भारत-सरकार/Government of India
रेल मंत्रालय/Ministry of Railways
दक्षिण मध्य रेलवे/South Central Railway

संख्या/No.77/2/P/Earth(T).

Technical Circular No.05/2022

Sub:- Provision of earth electrodes for equipments like CLS control panels,
service buildings, DG sets, water coolers, lifts and escalators etc.

Drawing No.ETI-OHE-P-7021;

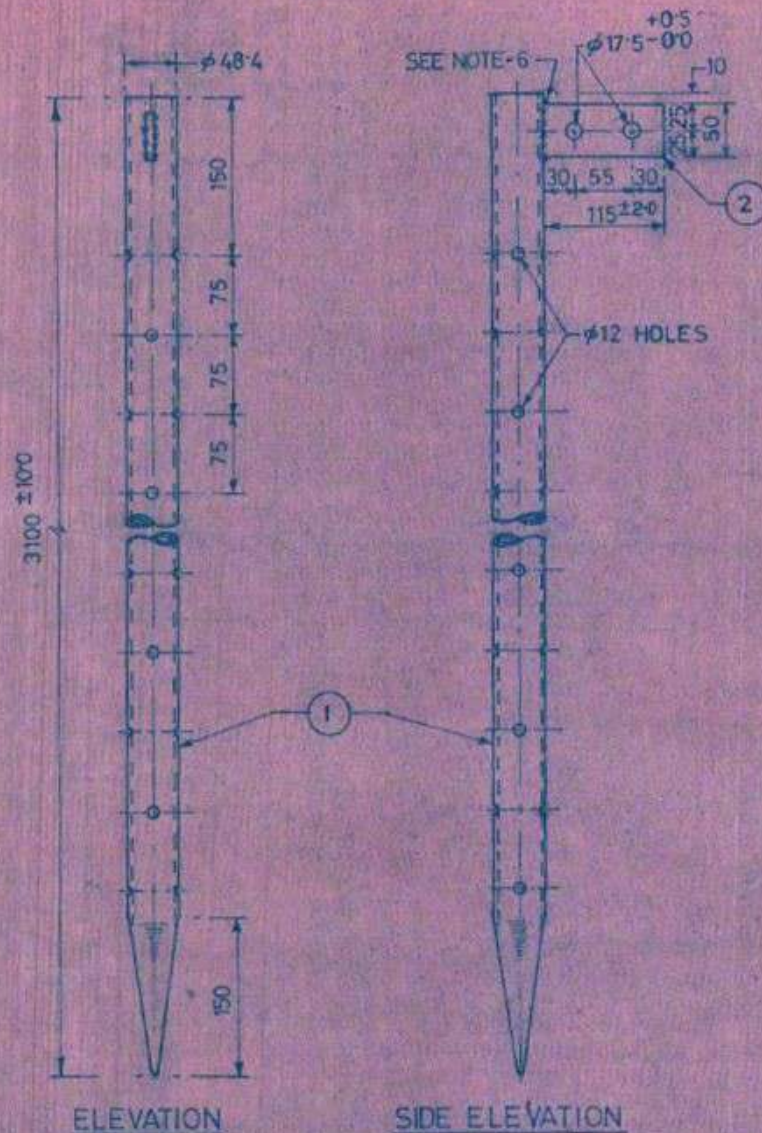
At present for power maintenance equipments earthing in following SCR Drawing No.SK.No.A3/10/M/R is used. As the earth electrode given in drawing is not as per CPWD specification or CORE/ALD specification decided that the above SCR drawing is withdrawn with immediate effect. For good quality electrodes, the following specification & drawing of CORE/ALD shall be used for all feature stores/works procurement. At locations other than sub-station.

Specification No.TI_LKO(PSI/38/2020 Dt.235/08/21 or latest. Copy of the drawing and specification is enclosed as Annexure-A & B. For substations earth electrode of 4M length confirming to RDSO drawing ETI/PSI/222-1 & RDSO Spec No.RDSO-TIOLKO(PSI)/38/2020 dated 25/8/21 to be adopted. Copy of Drawing and spec enclosed as Annexure D & B.

Further, to get quality electrodes, decided that the earth electrodes shall be procured from CORE/ALD approved sources only. List of CORE approved sources is enclosed as Annexure -C. In all future estimates earth electrodes as per above drawing only shall be included. For works tender/estimate rates, latest LOA from CPD/RE tenders may be obtained and adopted for all works for which tenders not called but detailed estimates sanctioned also shall follow above earth electrodes drawings as well as sources adopted including earth works sanctioned under Umbrella works for quarter service buildings etc. For procuring through stores rates may be obtained from any of the approved sources and indents placed for earth electrodes. No deviation for the above drawings on the approved sources will be allowed. List of Core approved sources along with latest drawing as well as specifications can be downloaded from CORE/ALD website or may be obtained from CPD/RE/SC.
